Responses to Anonymous Referee comments on “Influence of groundwater on distribution of dwarf wedgemussels (*Alasmidonta heterodon*) in the upper reaches of the Delaware River, northeastern USA”

Responses to Anonymous Reviewer #1 general comments

Figure 2

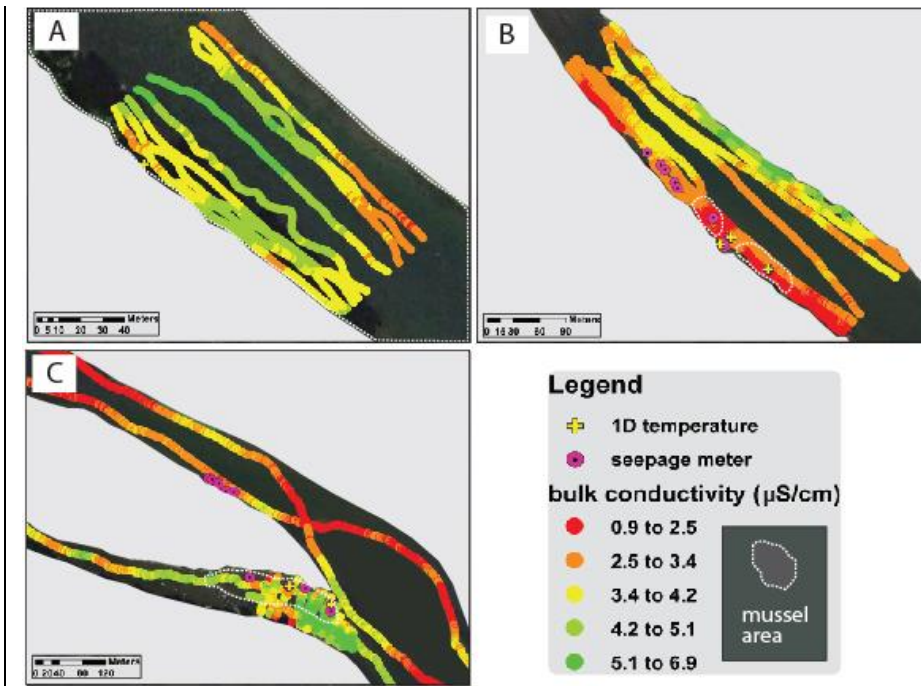
Reviewer 1: Figure 2 – the text (lines 172-175) refers to locations where seepage meters were installed.

However, the figure itself only mentions seeps, which I take to mean actual locations where seepage was observed. Moreover, on line 175, the authors mention locations S1 and S2, but no such locations are shown on the figure.

Reviewer 1: Figure 2 should be modified or a new figure included to show the locations of measurements of seepage (numbered according to Table 1). Note, locations M4 and M5 are also referred to in the text (line 260) but are not shown anywhere. This figure could also show the 1D sensor locations.

Reviewer 2: L133: The piezometers where groundwater samples were collected are not shown on Figure 2?

Authors' reply: The figure was increased in size to allow labeling of all locations where seepage meters and piezometers were installed, including the two locations S1 and S3 situated within the spring area at Site 2.

Authors' reply: We have revised the figure to show the locations of all seepage-meter and piezometer locations. We chose to present the 1-d sensor locations in Figure 4 only to reduce clutter in Figure 2.

We have revised the figure to allow us to add labels for specific seepage meter and piezometer locations.
